ANCHOR BOLT SETTING PLAN
(BOTTOM OF BASE PLATE ELEVATION: (-1'-10") (U.N.O)
(REF:S1.1)

07/24/2020			ISSUE FOR APPROVAL
DATE	NO.		DESCRIPTION
REVISIONS

APPROVER NOTES :

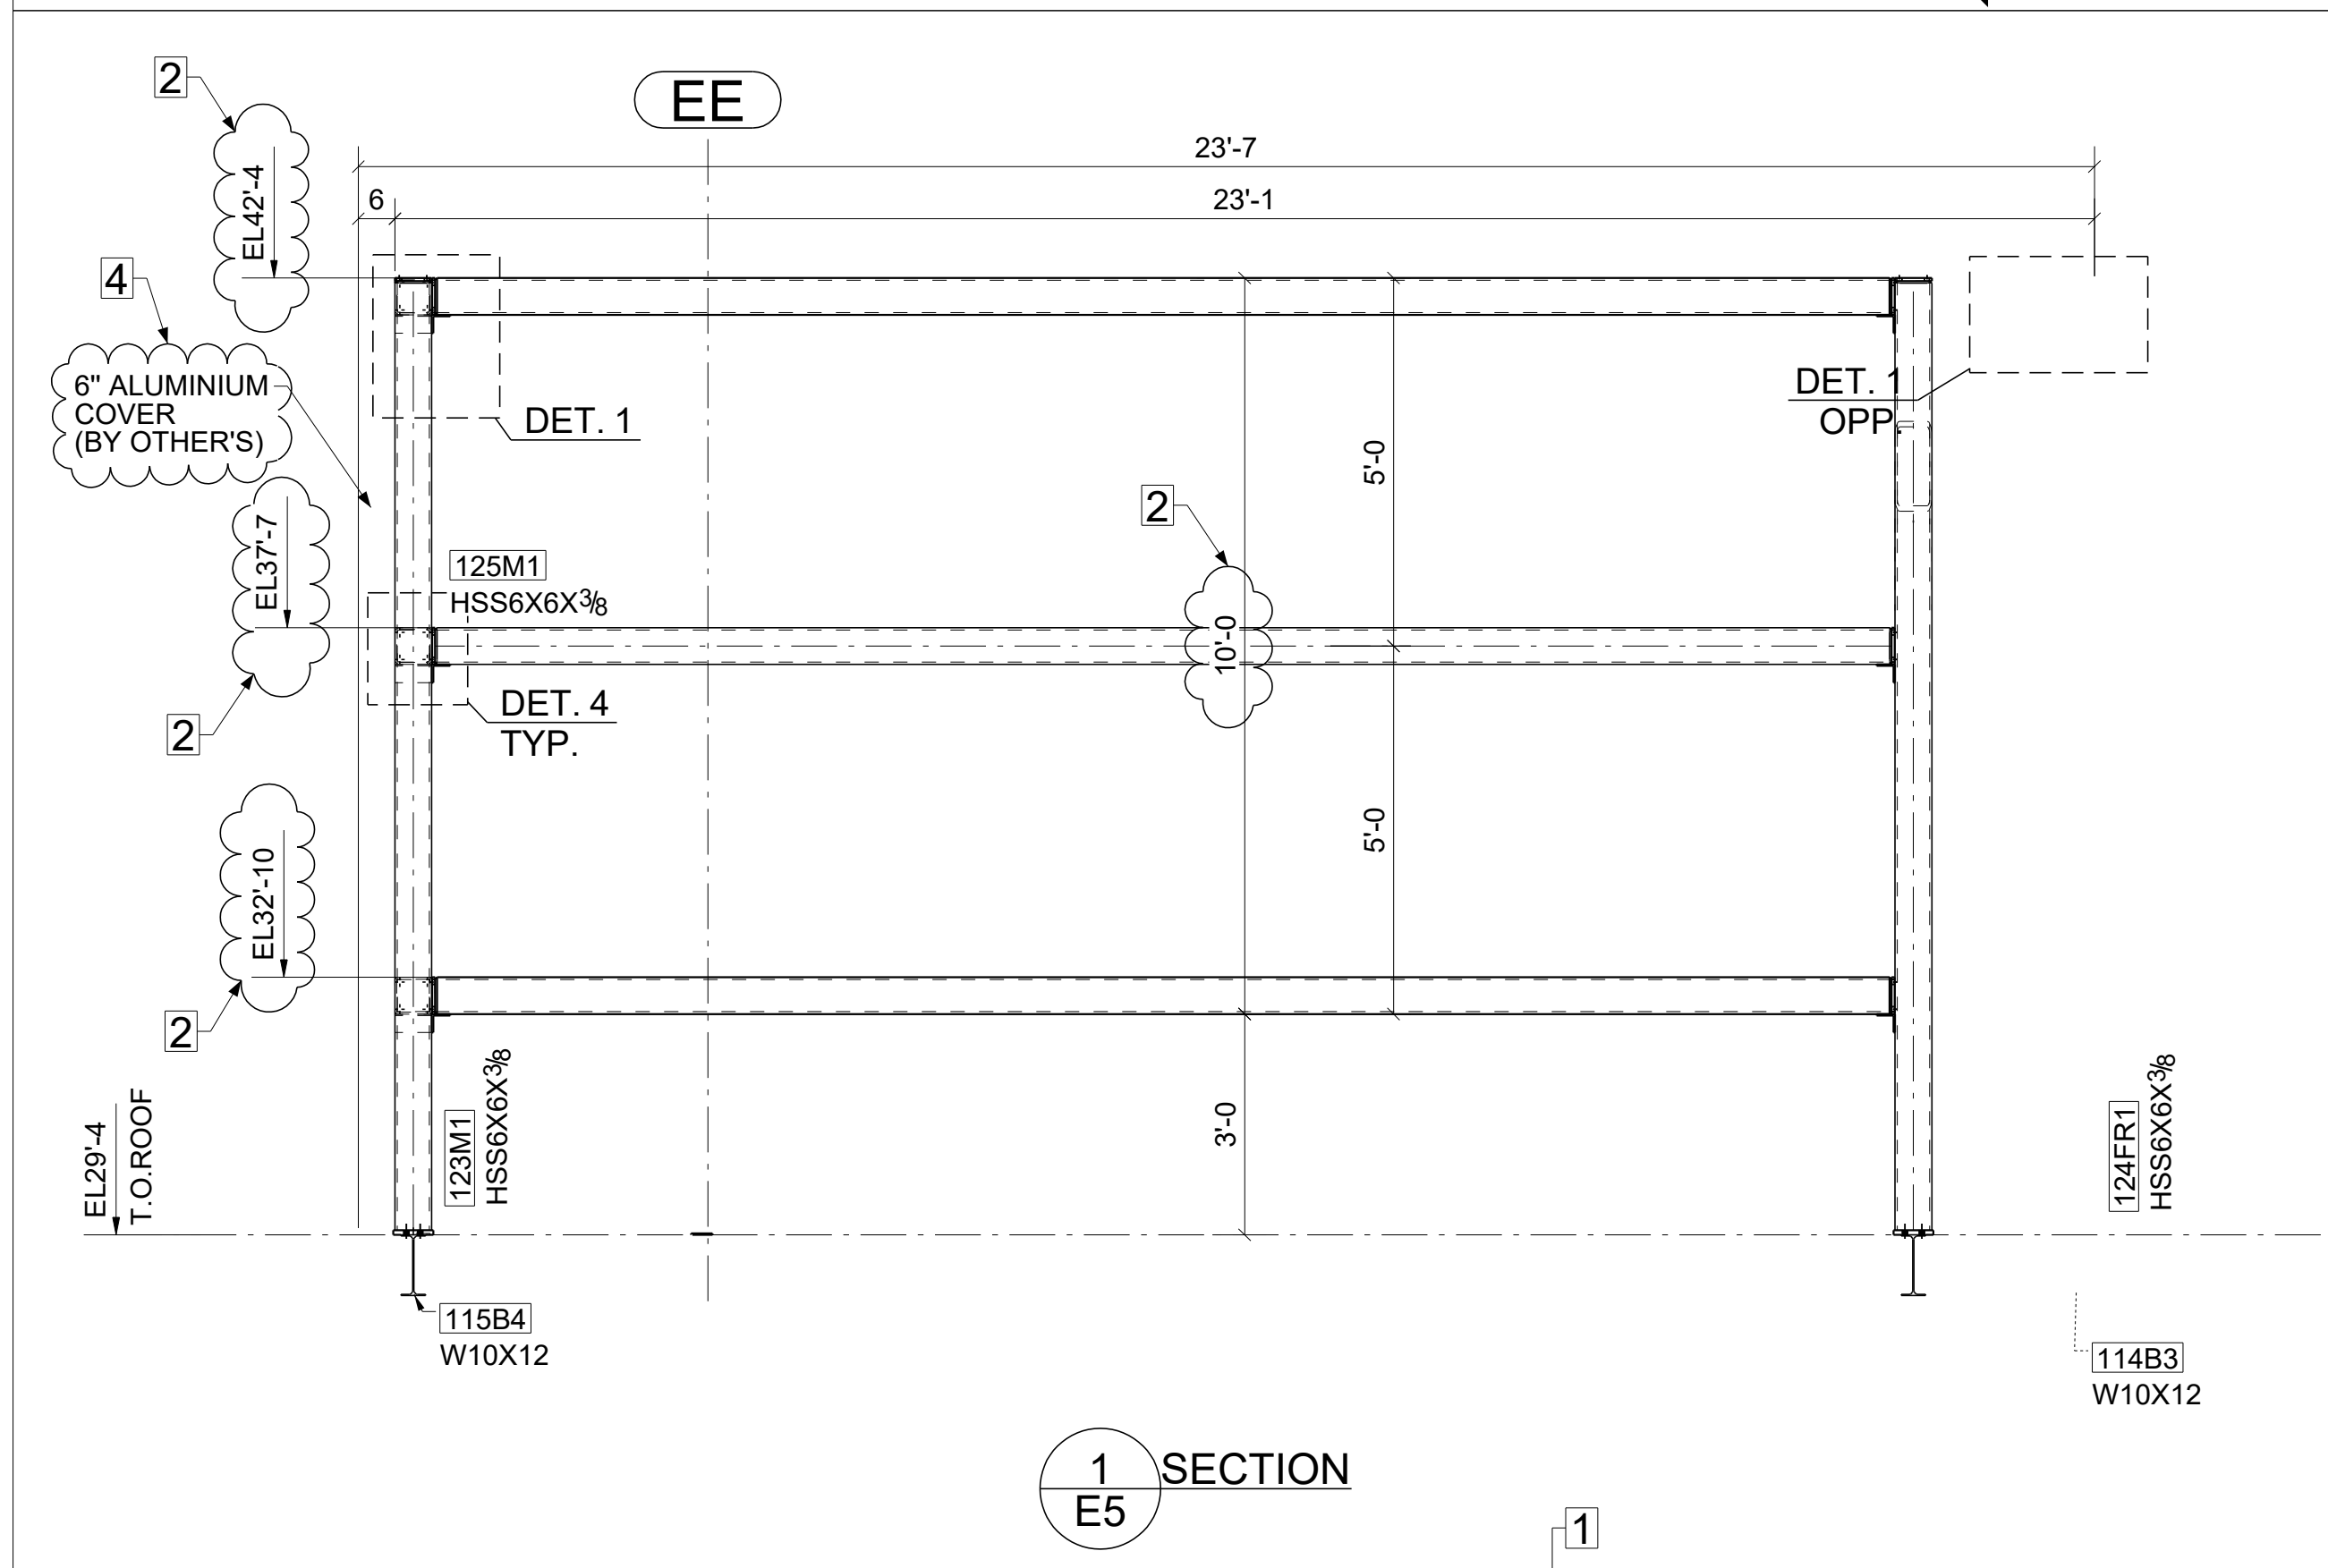
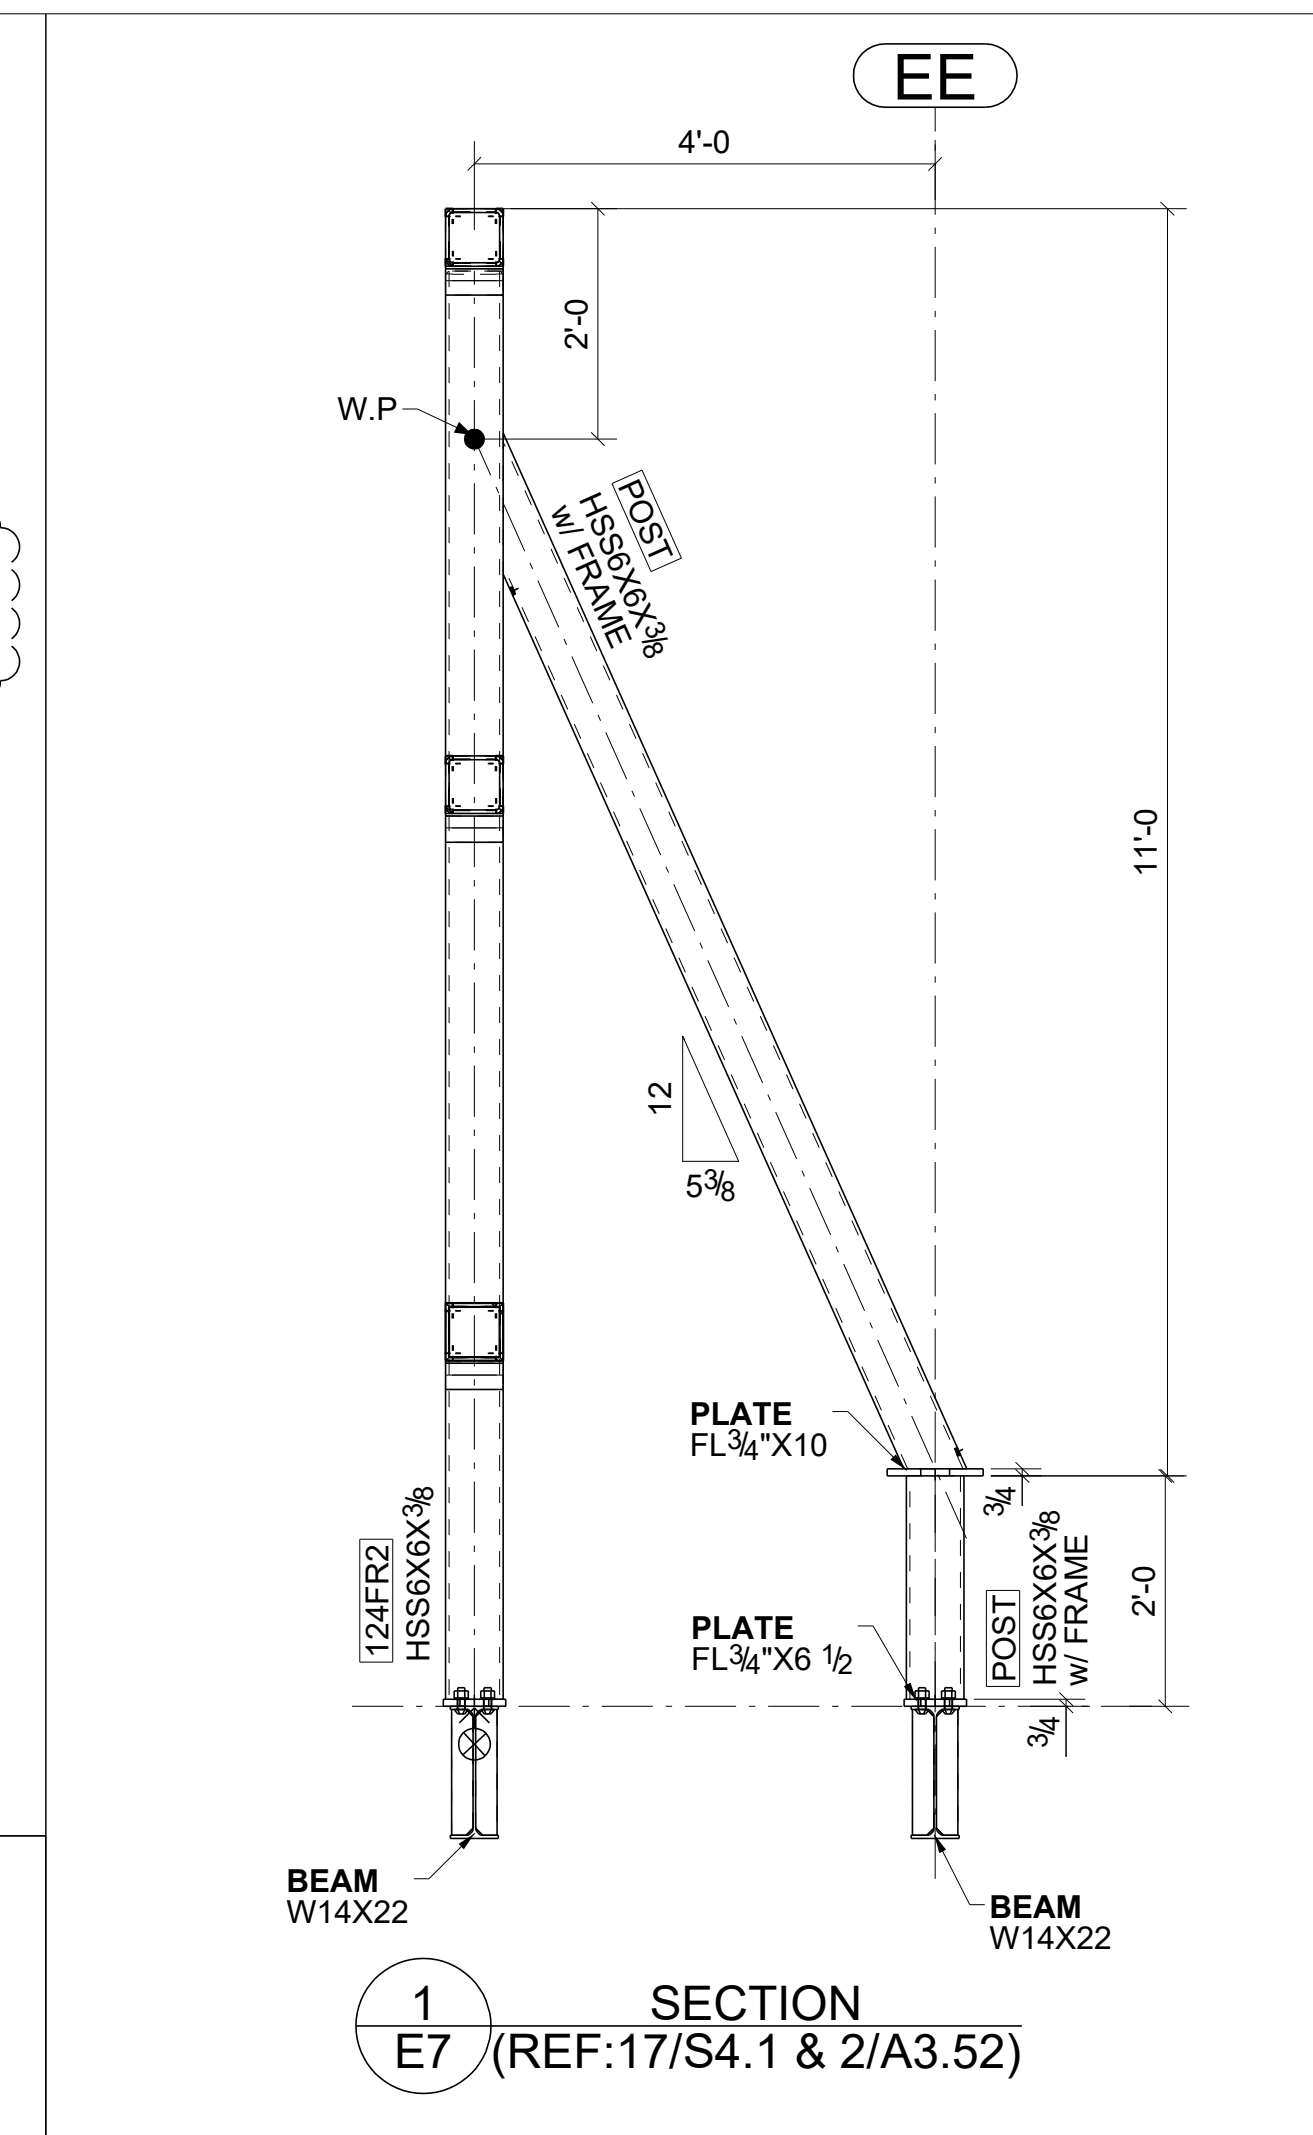
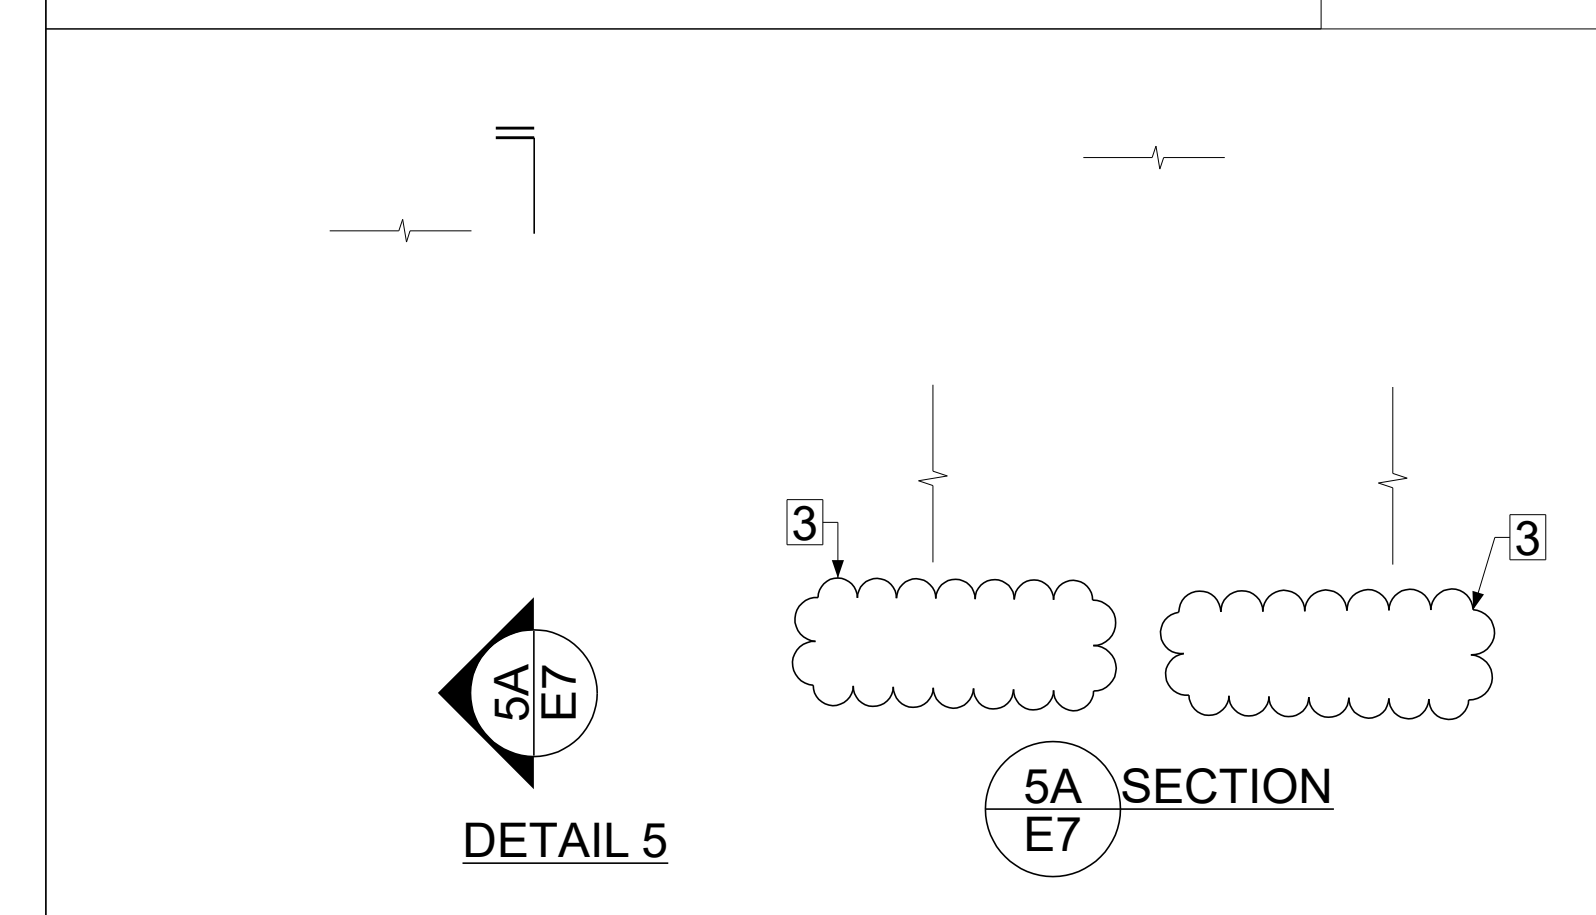
- PLEASE REVIEW AND CONFIRM THE CLOUDED ROOF SCREEN WALL SUPPOT STEEL CONNECTIONS FOLLOWED
- THE CLOUDED 10'-0" DIMENSION (PER STRUCTURAL) IS SHOWN AS 9'-0" IN ARCH DRAWINGS . ALSO IT IS INDICATED IN ARCH TO MATCH THE HEIGHT OF ROOF SCREEN WALL WITH EXISTING ROOF SCREEN WALL. HENCE PLEASE REVIEW AND CONFIRM THE CLOUDED DIMENSION AND ELEVATIONS OF ROOF SCREEN WALL.
- AT POSTS SEATING CONNECTION, WE ARE PROVIDING $\frac{3}{8}$ " THINK STIFFENER PLATES IN BEAMS TO ALIGN THETHE HSS FACES AS CLOUDED. PLEASE REVIEW & CONFIRM.
- FROM ARCHITECTURAL DRAWINGS, WE ARE ASSUMING THAT THERE 6" ALUMINIUM COVER TO THREE SIDES OF ROOF SCREEN WALL WHICH INCLUDED IN THE 55'-4" & 23'-7" ROOF SCREEN WALL DIMENSION SHOWN IN A.I.S.O. PLEASE REVIEW AND CONFIRM.
